RE: NIPSCO's Feedback in response to Capacity Deliverability on August 20, 2015 at MISO-PJM JCM

Issues with the External NR Proposal:

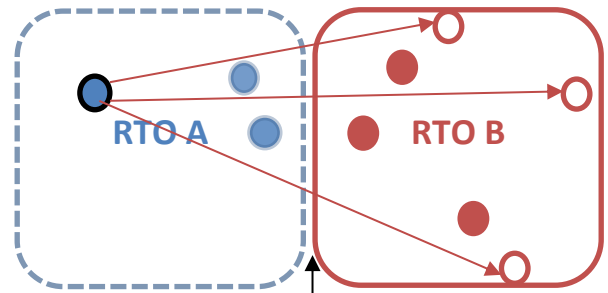
- MISO states in the proposed BPM-015 language that external NRIS requests requires the prerequisite procurement of firm Transmission Service (or TSR) to the MISO border in order to validate the External NRIS request. MISO has not defined "the MISO border" (e.g. an external bus, MISO bus, interconnection flowgate?) for deliverability study purposes and how generation at its borders is equivalently reflected in the study or if this is merely an assumption made through a policy requirement? Is it meant to preclude that the external resource is deliverable up to the MISO border but not all of MISO footprint; therefore, MISO requires a deliverability study of this external resource to ensure deliverability within MISO footprint from the MISO border? How does MISO ensure that a TSR in RTO A + Deliverability in RTO B = Deliverability from a single originating point in RTO A to ALL of adjacent RTO B? See below:

NOTE: Gen in A ● is not dispatched up (stressed) in this test. Only Gen in B ● is stressed per MISO Deliverability method.
→ Flowgates along seam potentially impacted

This method mentioned above is not proven and is not equivalent treatment of an external unit to an internal unit since the analysis is performed in 2 distinctly different studies in 2 distinctly different regions, and using separate methods and separate dispatch assumptions resulting in the flow gates between those areas not being stressed in a similar manner. These analysis gaps due to study inadequacy will either lead to cost shifts between RTOs or TOs if caught in planning processes or lead to real time/day ahead constraints since both RTOs would expect resources to be fully deliverable given the results of the deliverability study. However, there will instead be over-subscribed flow gates being applied additional capacity since MISO's study is not taking into account the proper stressed dispatch in external areas needed to ensure deliverability from the adjacent RTO into and throughout MISO.

Potential fixes: RTO joint deliverability with equivalent treatment of all generation resources in each region or coordinate network resource service (NR) generation dispatch between RTOs to apply to MISOs NRIS/Deliverability study's ramping method in its stressed peak case. This would basically dispatch external PJM generation the same as internal MISO units to determine if units are deliverable under peak conditions. Furthermore, an off peak case will likely be required since MISO's capacity is moving towards a seasonal construct where an off peak case would be needed. This would further necessitate an update to the Deliverability white paper document for method of performing off peak analysis along with the treatment of external RTO generation which takes into account proper coordinated dispatch assumptions in the off peak case in external areas as well. Simply using existing dispatch assumptions from MMWG (base level dispatch) in an off peak MISO case would amount to additional deliverability study issues.
